Docket Item #2
Design Review Board Case #2009-0002 (Advisory only)
EESAP Blocks 11 & 12 - 2210 Eisenhower Avenue

Purpose of Application	
Concept design review of a development proposal for two blocks in the Eisenhower East Small Area Plan area. The proposal includes construction of two residential mixed-use buildings at the intersection of Port Street and Eisenhower Avenue adjacent to the Eisenhower Metro Station.	
Staff Reviewers:	Thomas Canfield, AIA tom.canfield@alexandriava.gov Natalie Sun, AICP, LEED AP natalie.sun@alexandriava.gov Gary Wagner, RLA gary.wagner@alexandriava.gov

DESIGN REVIEW BOARD ACTION, NOVEMBER 19, 2009:

ATTACHMENT C

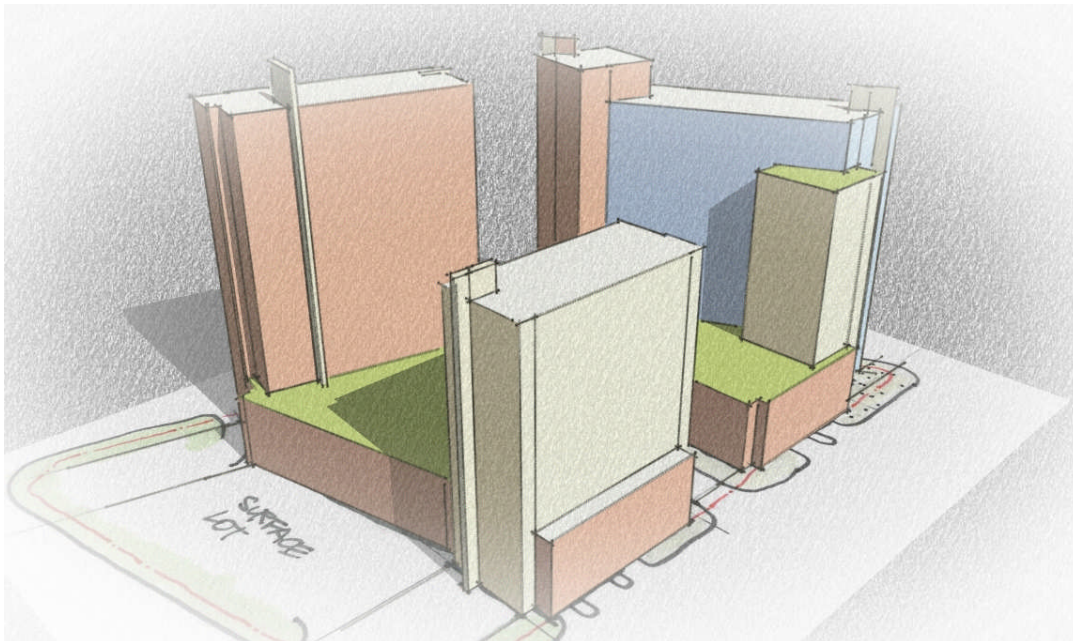
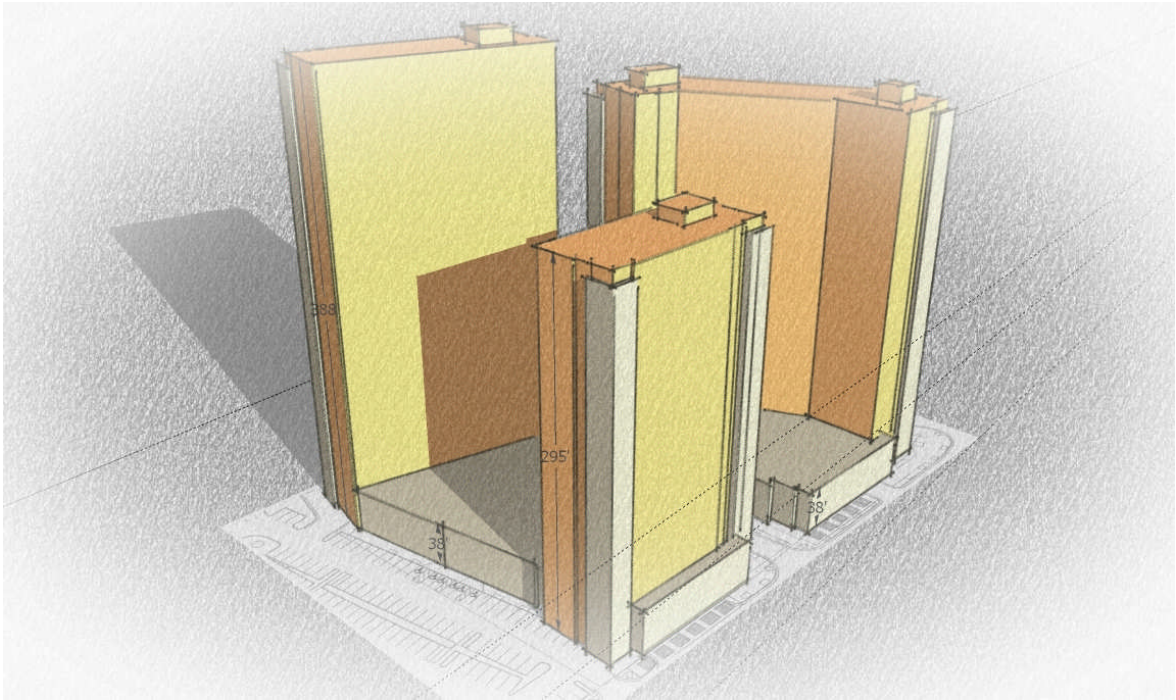
The current scheme still lacks a refined design parti, or a clear concept. Particularly for a project of this size and magnitude, it is important to have a design concept that carries the entire project. A strong parti would address the issues of differentiation of buildings and connections between them.

Prior to the July DRB hearing, staff analyzed the applicant's proposal through a series of parti diagrams included in Attachment A of the July DRB staff report (See Attachment F). The parti for the adjacent Lane project on Blocks 19 and 20, for example, is a geode concept in which unified open space courtyards form a north-south axis that splits the buildings, revealing glassy internal façades. Absent from the current Blocks 11 and 12 proposal is a concept that would, for example, provide a rationale for materials expression/selection throughout all buildings, design treatment of courtyard versus street-facing facades, tower articulation/expression, or how the buildings address the highly variable contexts that surround the site. See Attachment C for the applicant's parti progression and staff's parti study.

Figure 1. Ground floor and garage ramp study by City staff.

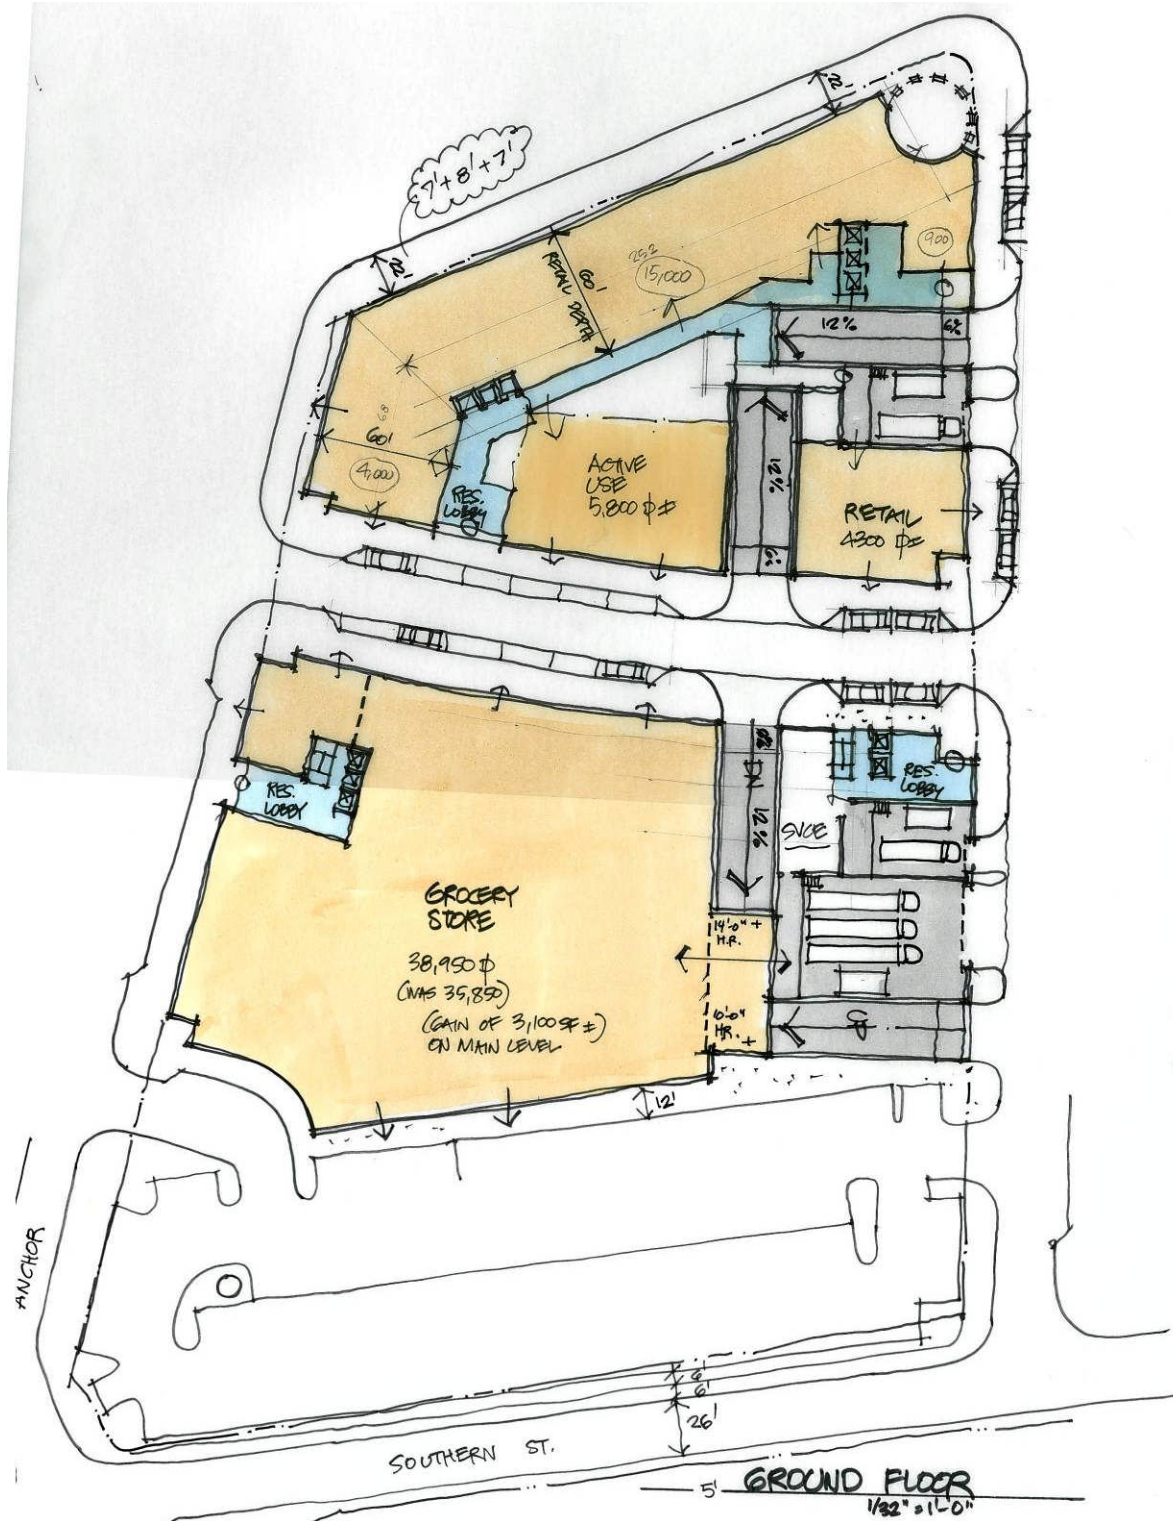
The site plan currently shows four access points to garage ramps (two per block face) as well as access to an internal surface parking lot on Block 12. Staff has been encouraging the applicant to reduce the number of garage access points on Dock Lane as required by Conditions 125 and 129 of the Stage 1 DSUP to make the street more pedestrian friendly and to possibly allow more active use/retail on the street. Staff believes that two garage ramps could be located on Port Street and has expended a substantial amount of time demonstrating that the ramps can function in this location.

Staff continues to feel that the evolving character and location of Dock Lane through this project warrants exploring the redesign of the ramping system to allow engaging the street with active/retail use to the greatest extent possible. The potential gains, which include exposure for Harris Teeter on Dock Lane, increased retail frontage, increased on-street parking on Dock Lane, and removal of the garage ramps from the building faces, outweigh the adverse impact of additional curb cuts on Port Street.

Figure 2. Parti studies by City staff.

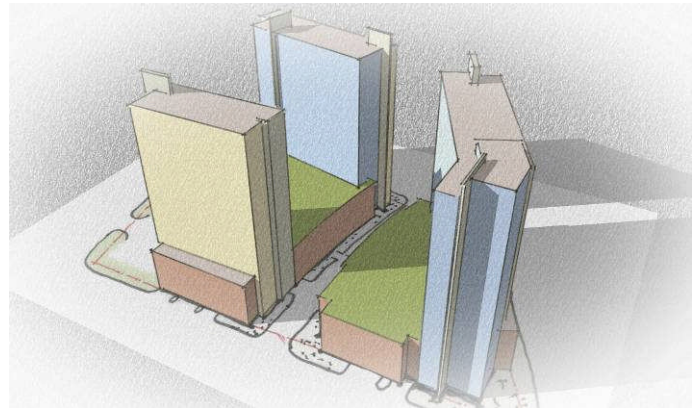
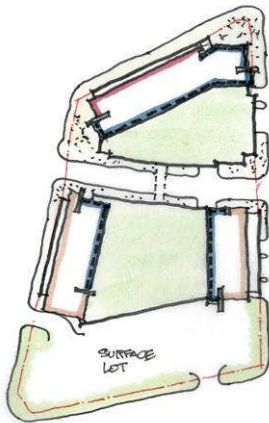
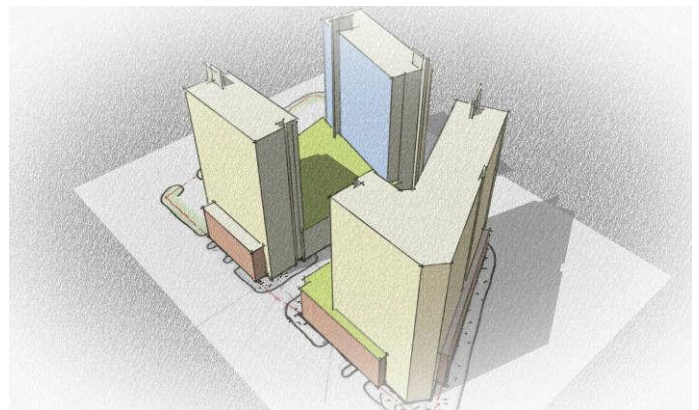
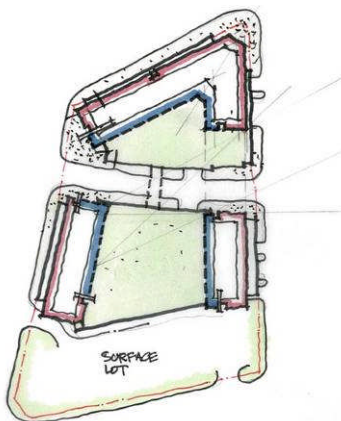
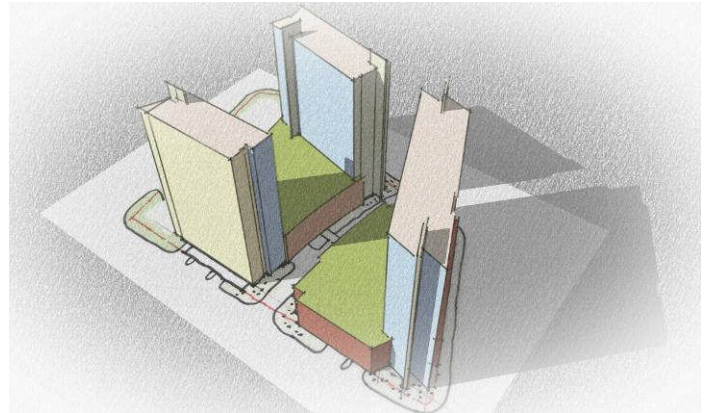
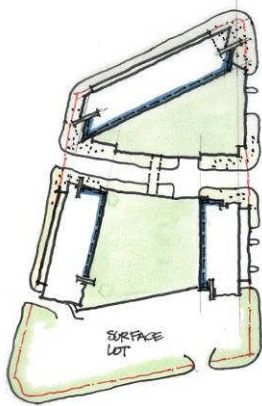
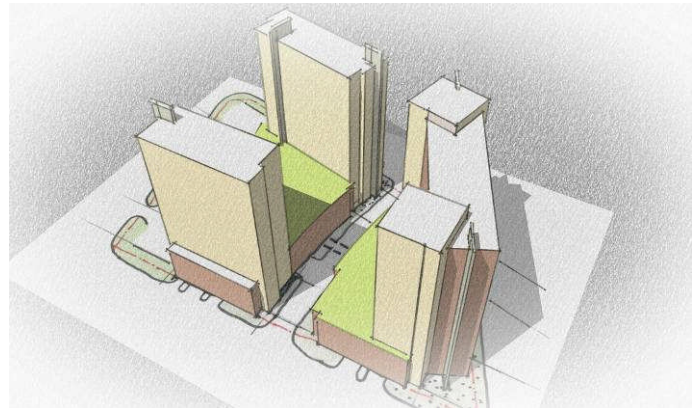
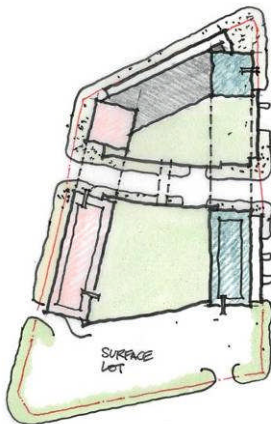
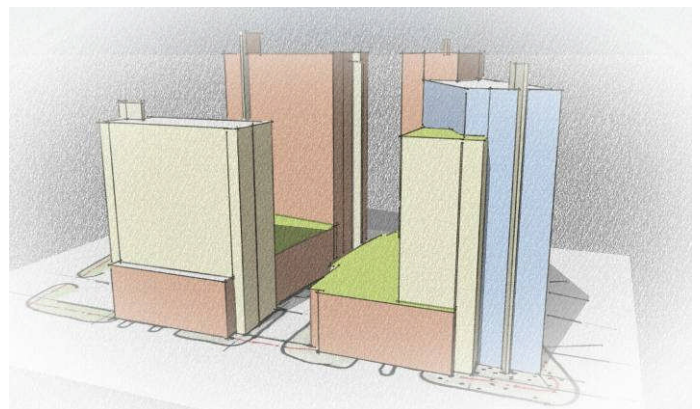
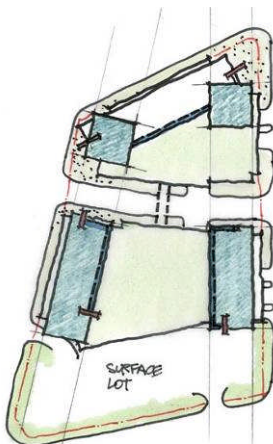
The overall building massing is boxy in appearance, projecting an image of three utilitarian vertical slabs. The tower slabs appear too similar to each other, with minimal articulation, nondescript roof features, and uniform heights. Since the treatment of the horizontal bases is generally consistent throughout all three building facades, they in fact emphasize the sameness of the building massing. This all leads to an overall impression of three unarticulated vertical slabs on top of a podium base. As one of the major new building projects being planned for the Eisenhower East district, this development should play a major role in shaping the Eisenhower East skyline and needs a more dynamic and articulated massing plan. Staff has studied the applicant's proposal through a series of parti diagrams shown in Attachment A.
